Lake Lothing
**THIRD
CROSSING**

Document SCC/LLTC/EX/4: Errata Report

PINS Reference Number: TR010023

Date: 20 /11/2018

Figure 1- Designated Sites

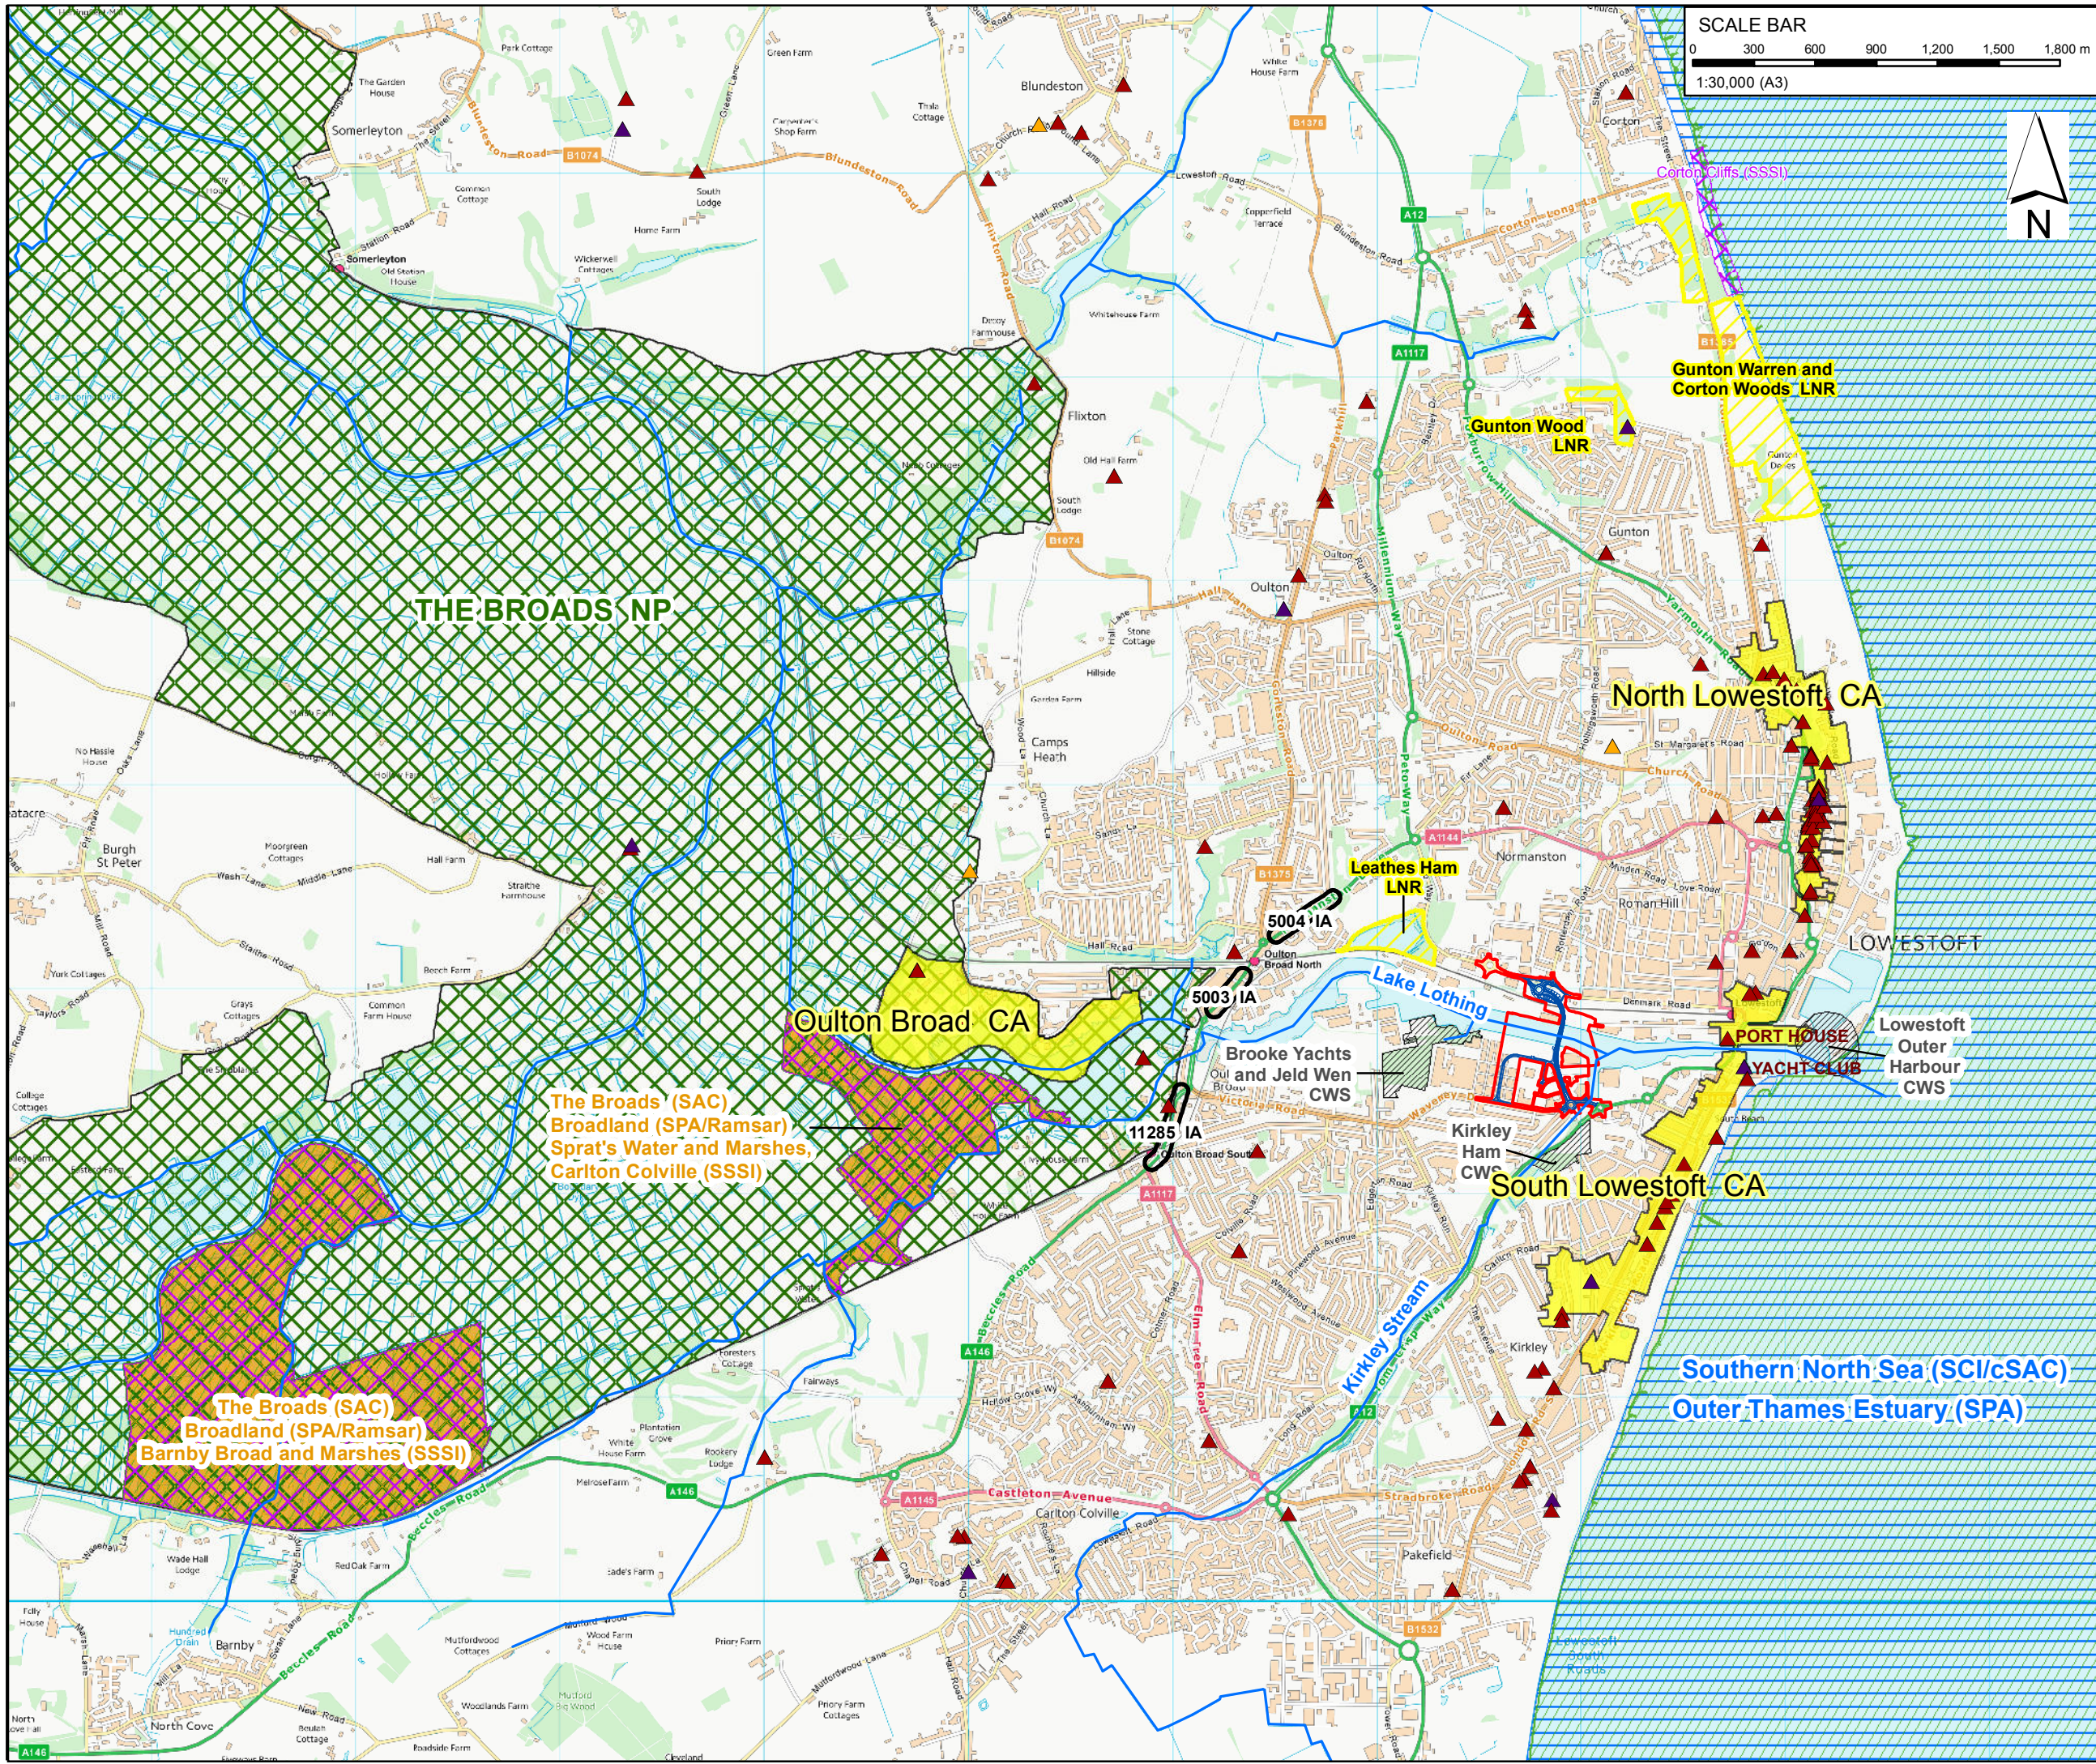
6.1 – ES Vol 1	Environmental Statement	Omission.	Figure 4.2 does not show the SSSI's listed in Paragraph 4.4.2 and an updated figure is included at Figure 1.	Figure 1

Figure 2 - Kirkley Ham CWS

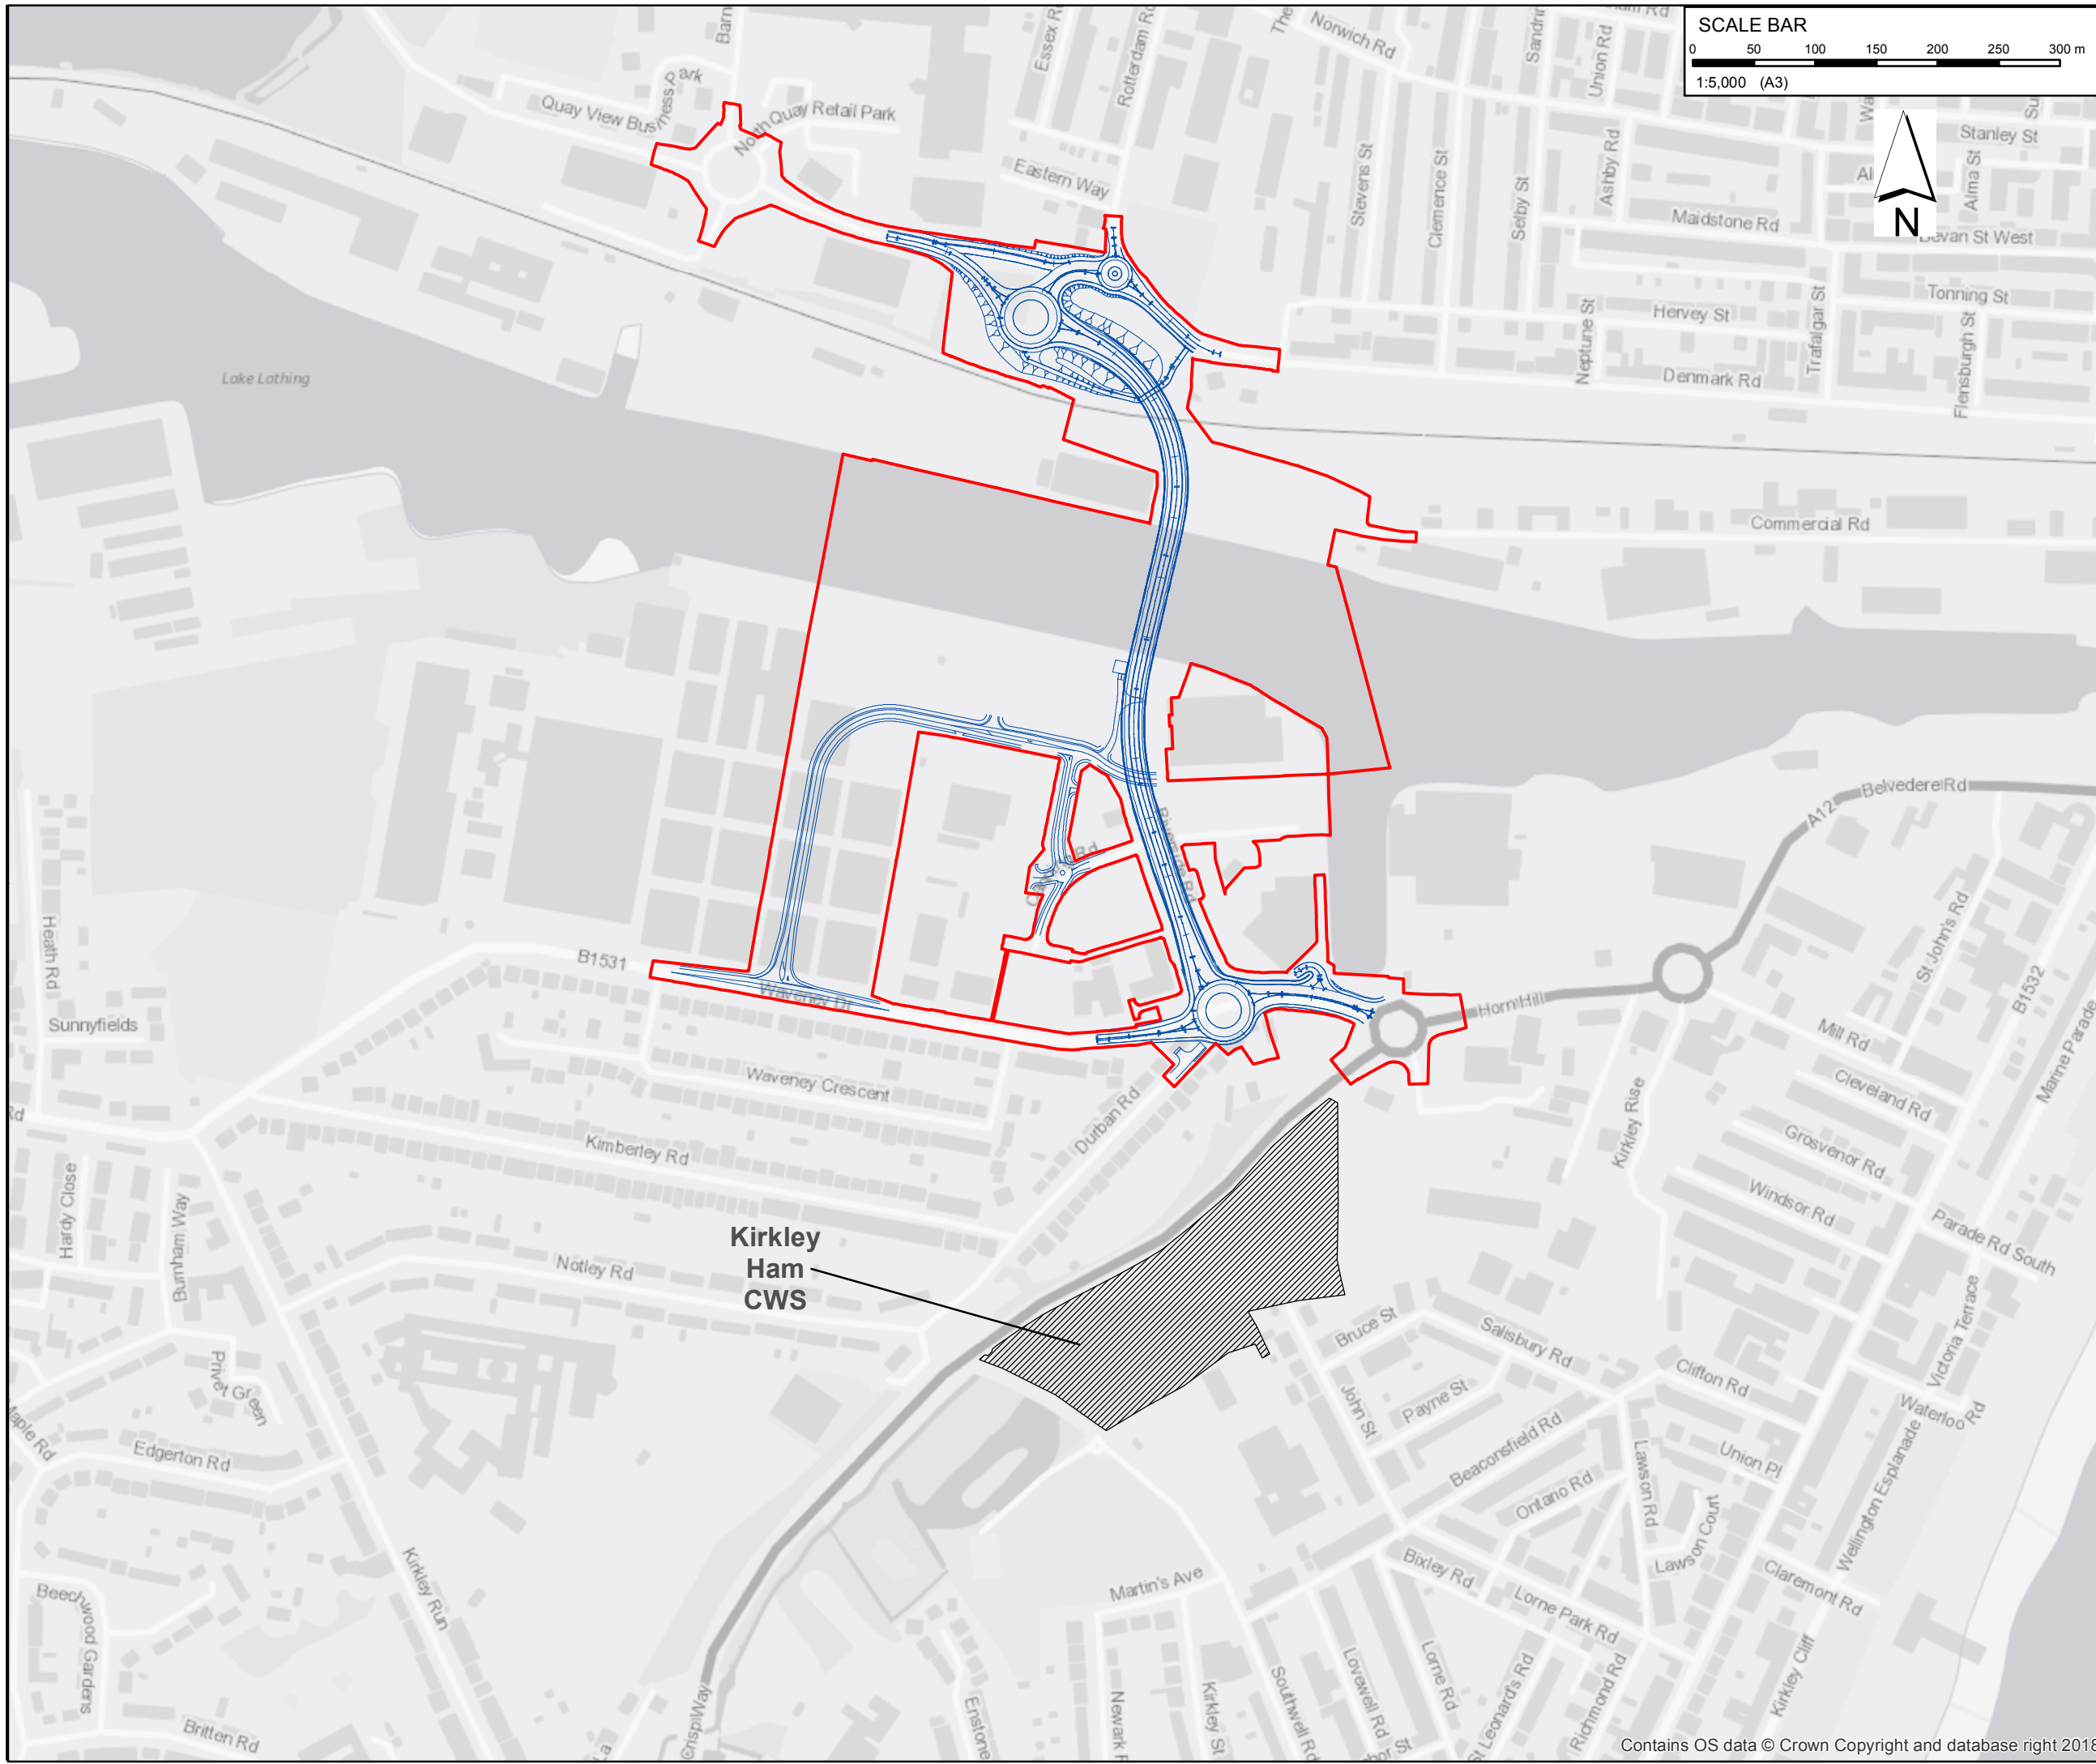
6.1 – ES Vol 1	Environmental Statement	Clarification	The incorrect outline of Kirkley Ham CWS is shown on Figure 4.2 and 4.1. However, this is attributable to the publicly available boundary being out of date and the actual outline of Kirkley Ham CWS is smaller as shown on Figure 2.	Figure 2
